## Wisconsin Department of Transportation

**Proposal #18: 1130-64-76, WISC 2024306**  
**Appleton – De Pere**  
**Northland/STH 15 Intchg B440315/16**  
**IH 041**  
**Outagamie County**

**1130-64-81, WISC 2024229**  
**Appleton – De Pere**  
**Capitol Drive Overpass B440317**  
**IH 041**  
**Outagamie County**

This is Addendum No. 02, which provides for the following:

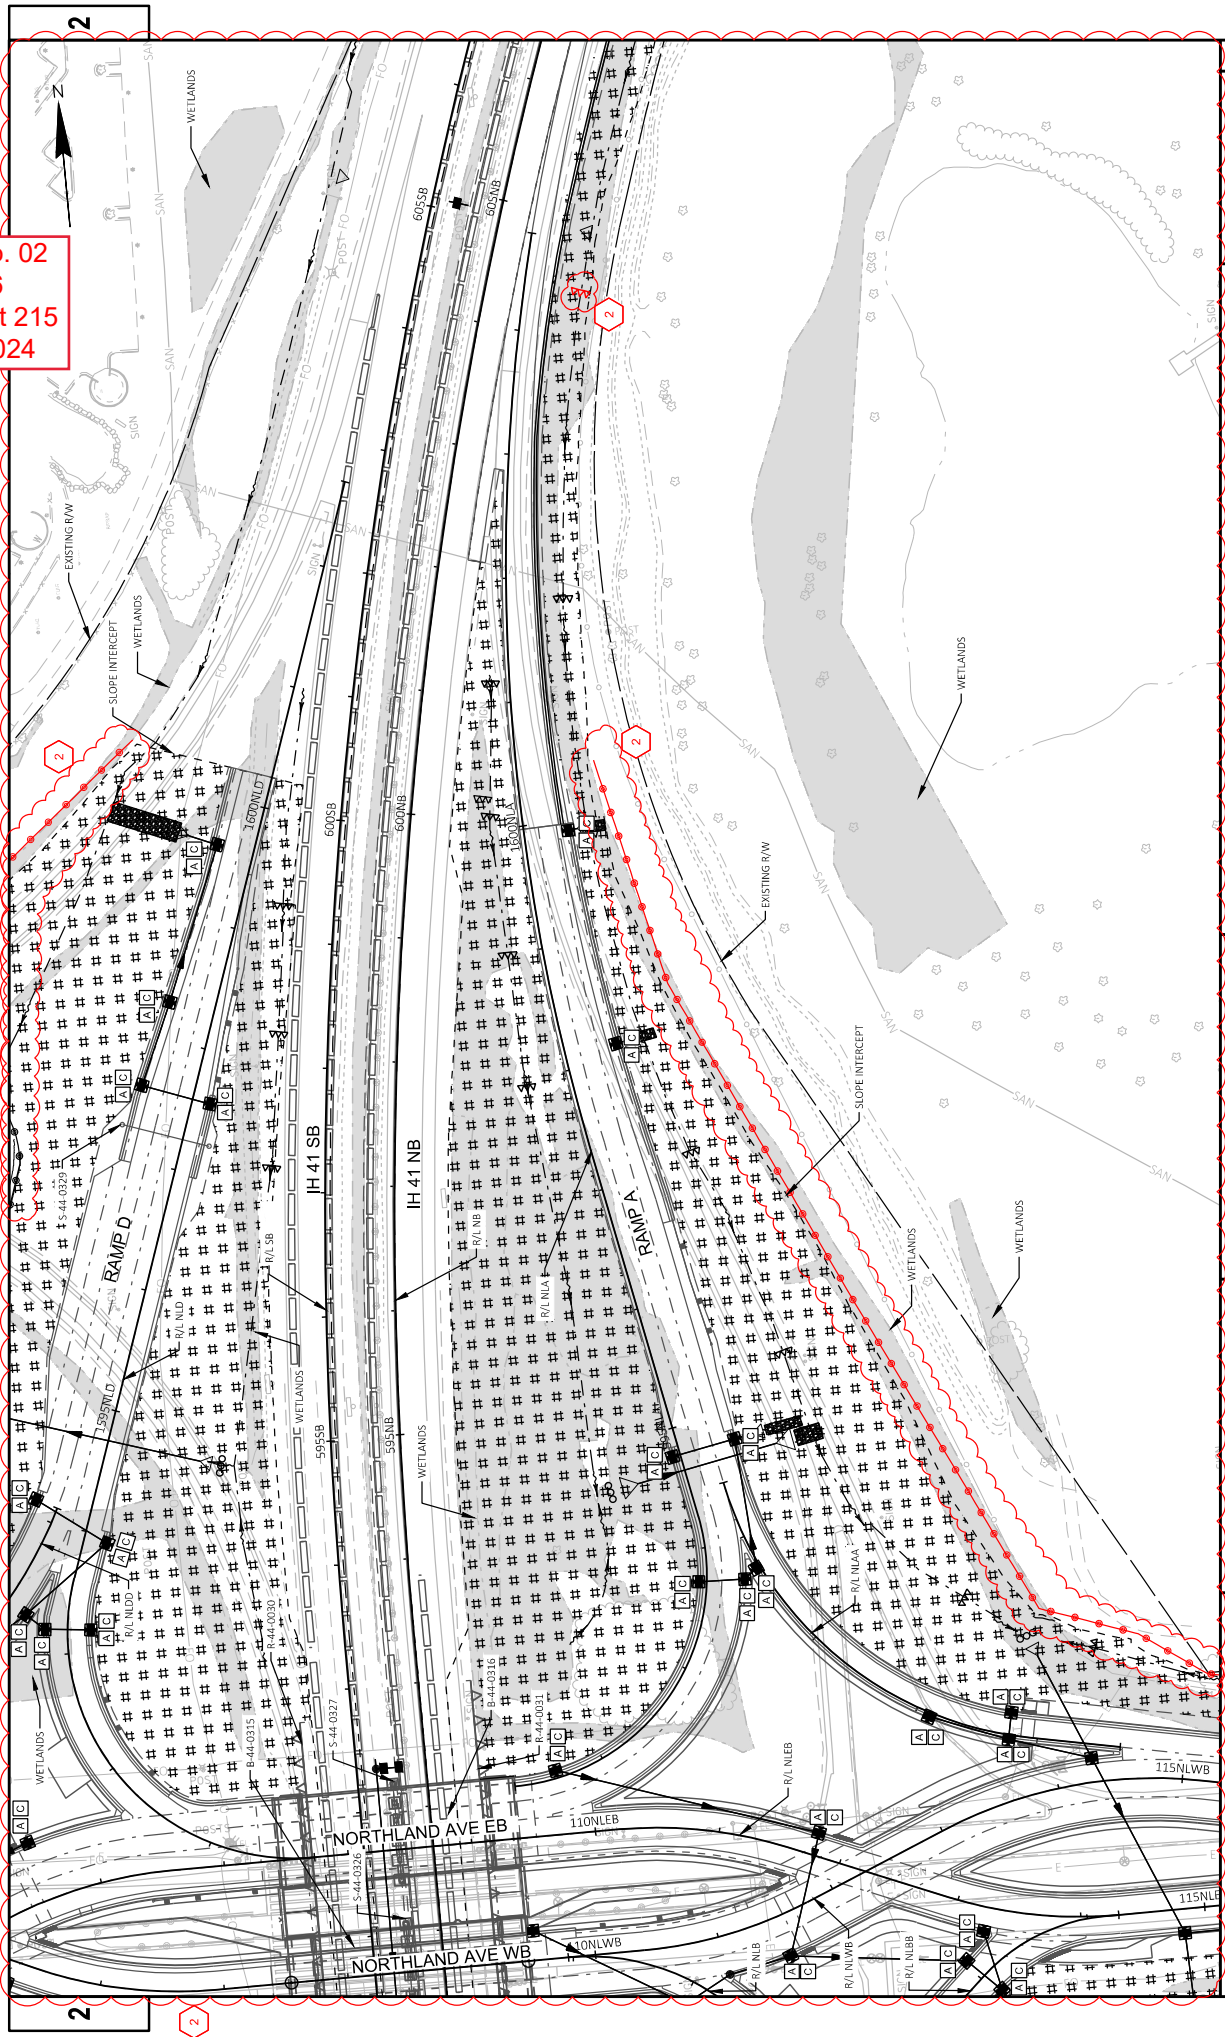
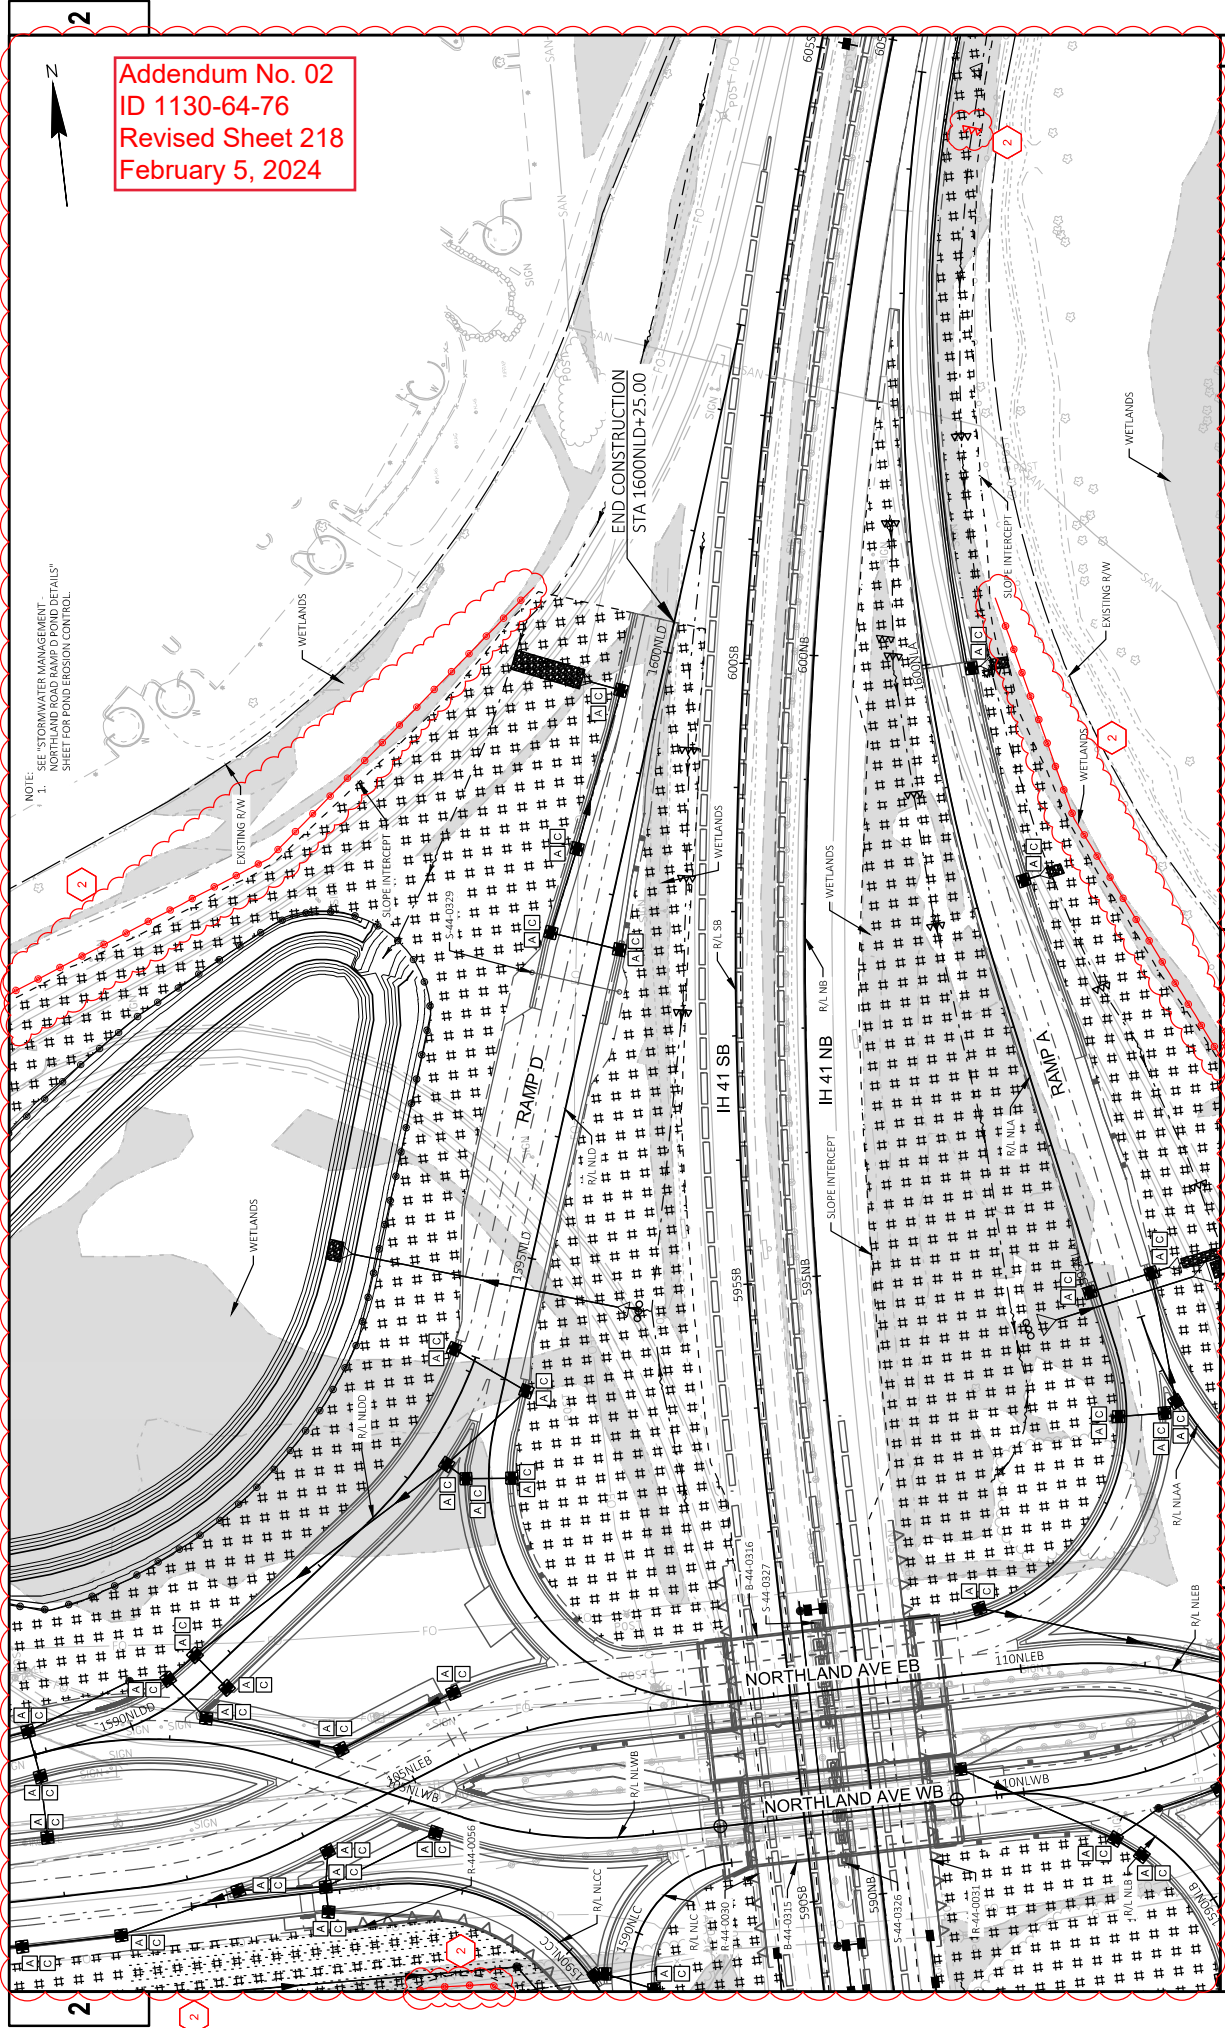
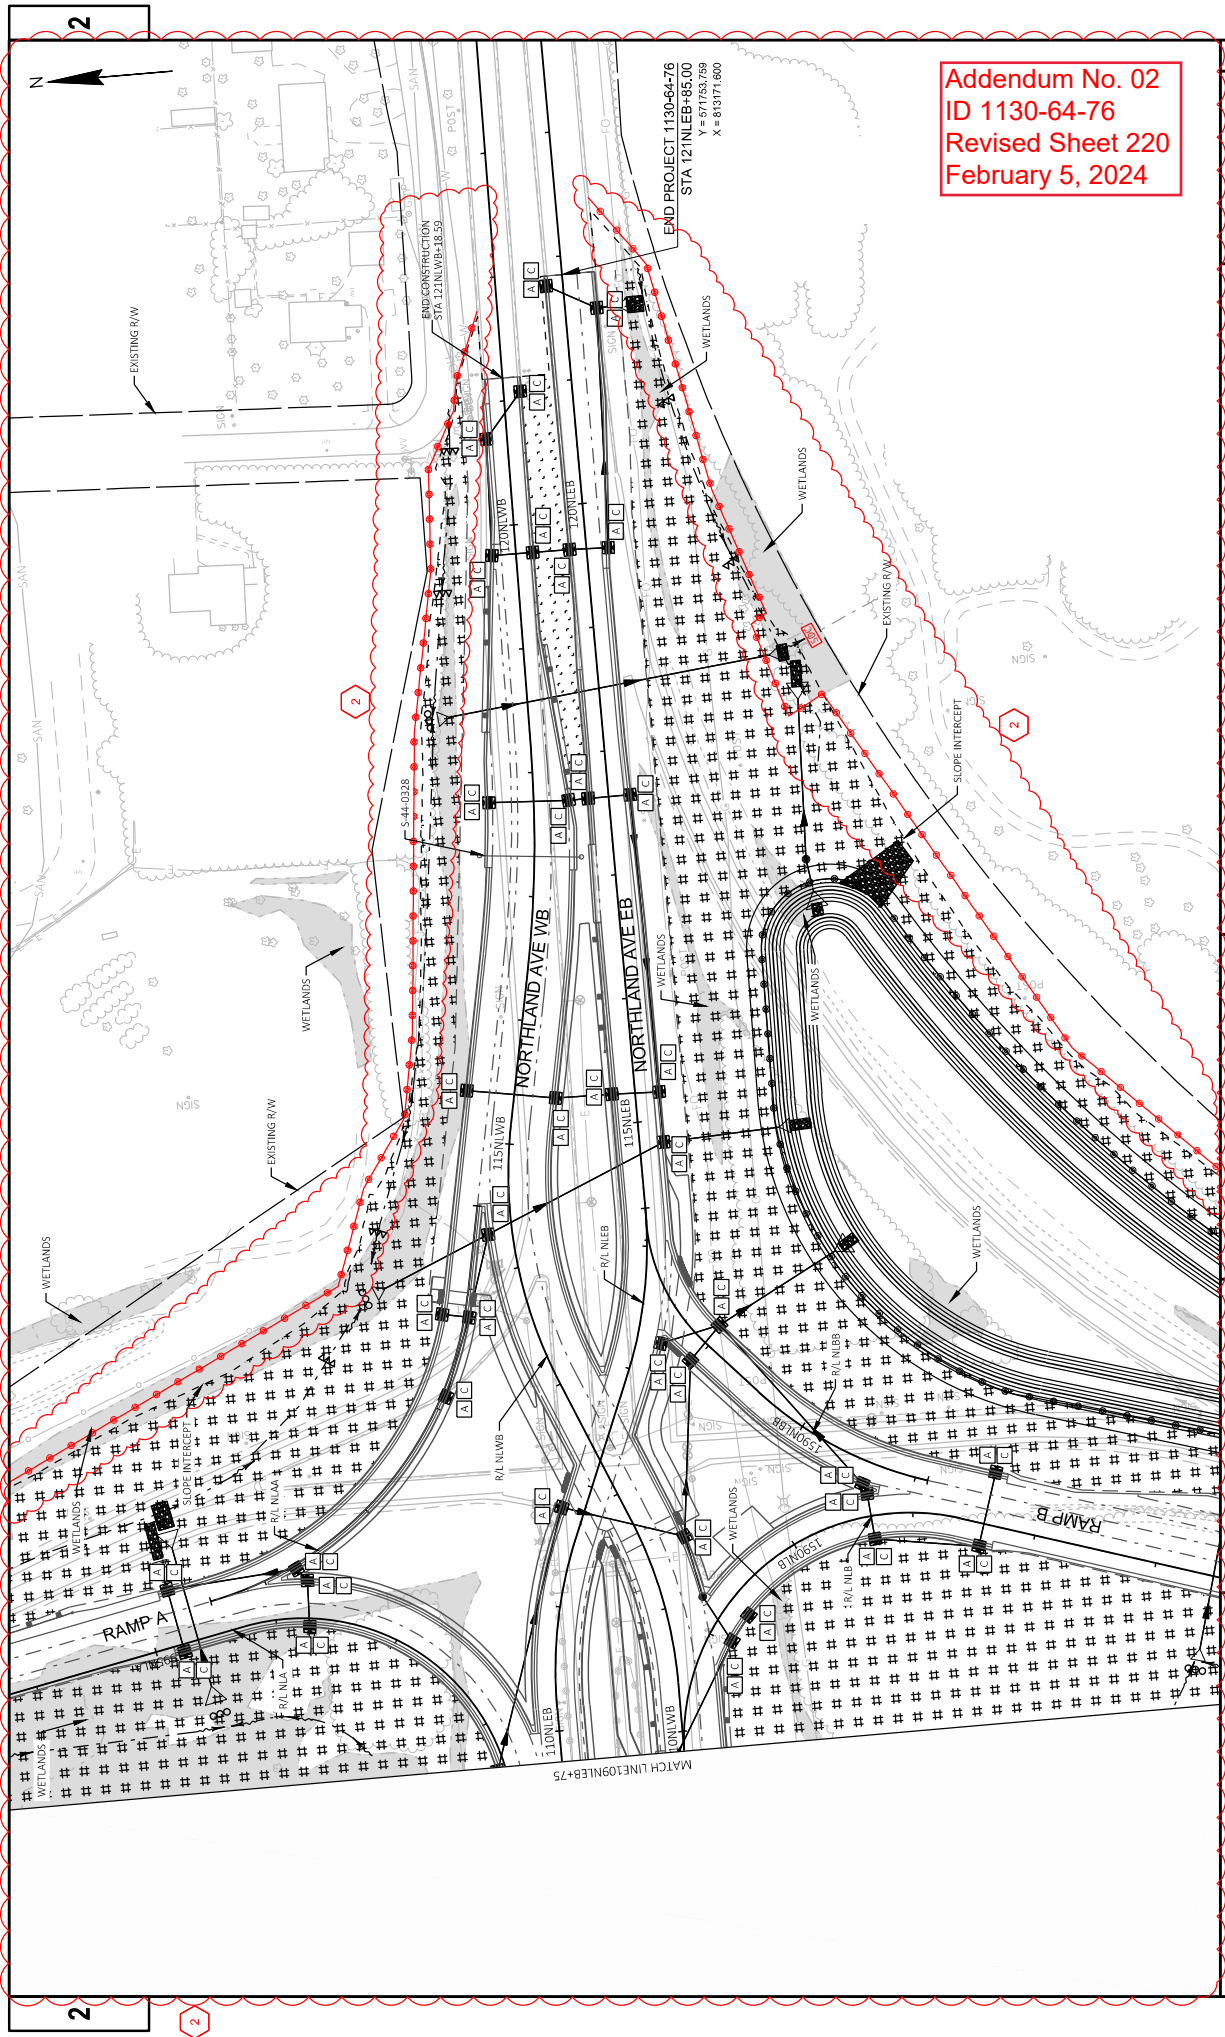
206-212	Updated proposed pavement linework to gray for clarity.
213-222	Updated proposed pavement linework to gray for clarity. Updated silt fence, temporary ditch checks and/or added stone ditch check.
227	Added STH 15 ramp D ditch grading note
237-238	Adjusted coordinates, rim elevations, and structure depth of 6472-S2.
237	Adjusted inlet coordinates of pipe between inlets 6472-S2 and 6473-S2.
240-241	Converted multiple SSRCP Class III 18-Inch pipes to Class III-A
270	Updated Lighting Plans – Bridge Abutment Conduit Detail.
427	Removed superelevation data for Ramp NLC.
455-456	Updated quantities for bid items: Riprap Medium, Riprap Heavy, Geotextile Type HR.
459-463	Updated quantities for erosion control bid items
464	Updated quantities for bid items: Fertilizer Type B, Seeding Mixture No. 30, Seed Water.
473	Updated quantities for bid item: Base Aggregate Open-Graded.
474	Removed quantities for bid item: Coloring Concrete WisDOT Red.
